dsPIC33CH512MP508 Family Silicon Errata and Data Sheet Clarification

The dsPIC33CH512MP508 family devices that you have received conform functionally to the current Device Data Sheet (DS70005371D), except for the anomalies described in this document.

FIGURE 1-1: I/O RAMP

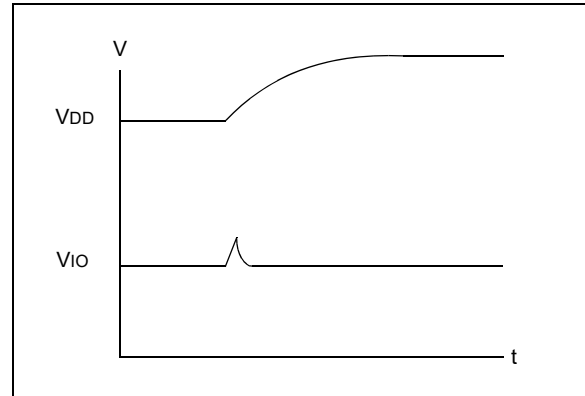
During a fast device power-up, when the V_{DD} ramp is less than 4 mS, the I/O pins may drive up to 100 μ A current for a duration of up to 10 μ S (Figure 1-1).

1. Slow down the V_{DD} ramp time (greater than 4 mS for V_{DD} to ramp 0V to 3.3V).
2. Ensure the circuitry that is connected to the pins can endure this pulse.

Example applications affected may include complementary power switches, where a transient current shoot-through might occur. High-voltage applications with complementary switches should power the high-voltage 200 μ Sec later than powering the dsPIC[®] device to avoid the current shoot-through. This behavior is specific to each device and not affected by aging.
